From: Hon, Andrew
Sent: Wednesday, October 19, 2016 8:32 AM
To: Murray, William R. (Bill) (Bill.Murray@duke-energy.com) (Bill.Murray@duke-energy.com)
Subject: Audit Plan for Brunswick MELLA+ License Amendment Request Review

REGULATORY AUDIT PLAN FOR BRUNSWICK STEAM ELECTRIC PLANT
UNIT NOS. 1 AND 2
TO SUPPORT REVIEW OF THE LICENSE AMENDMENT REQUEST
REGARDING CORE FLOW OPERATING RANGE
EXPANSION MAXIMUM EXTENDED LOAD LINE LIMIT ANALYSIS PLUS
DOCKET NOS. 50-325 AND 50-324

Figure 1 Schematic of first stage of mechanistic separator (Figure 10-13 [1])

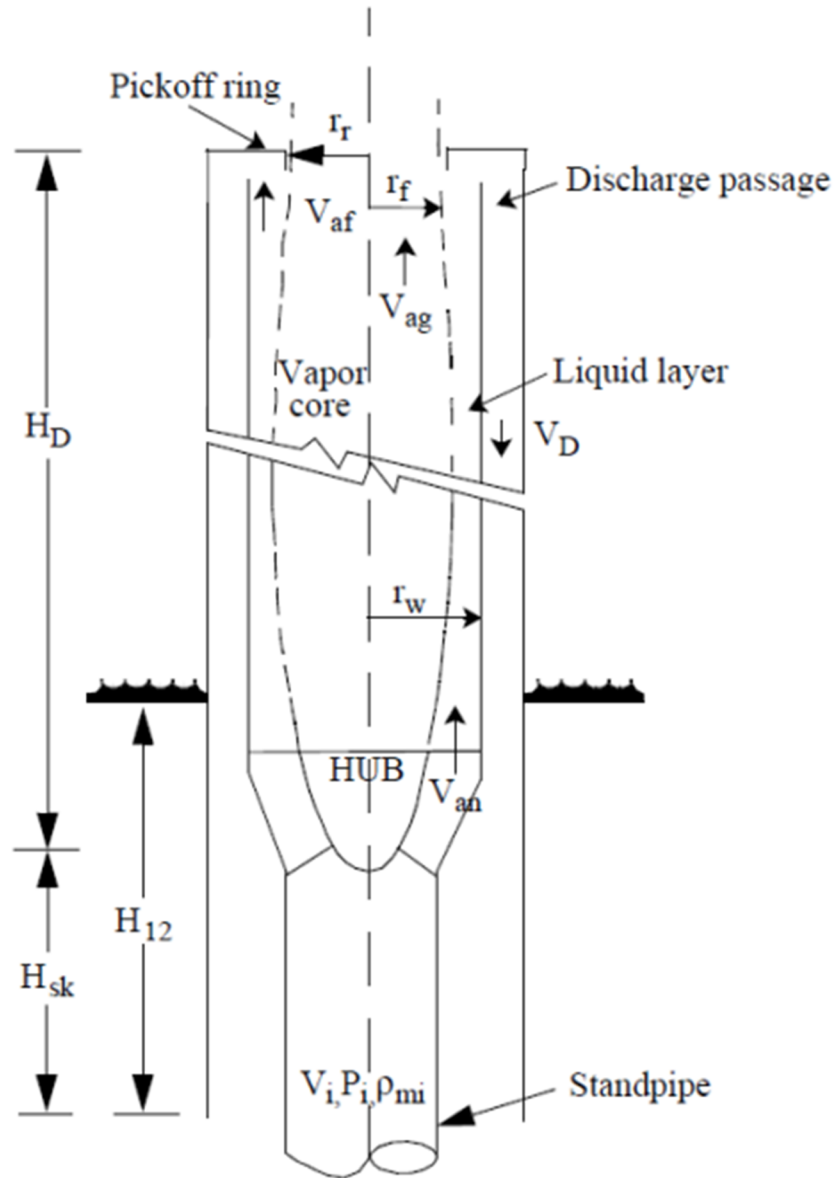
- a. Number of stages in the separators.
- b. Geometric data for each stage (wall radius, “pickoff” (liquid return) ring radius (see Figure 1), flow area, discharge diameter, barrel length, vane position, discharge loss, and effective L/D, or information from which these could be calculated).
- c. Hub inlet radius.
- d. Swirl vane angle relative to the horizontal (degrees).
- e. Free volumes for each separator (or in total) inside the standpipe, the conical (swirl vane) section, the inner cylinder of each stage, and the liquid return section for each stage.
- f. Arrangement (e.g., triangular or square lattice) and separator pitch.
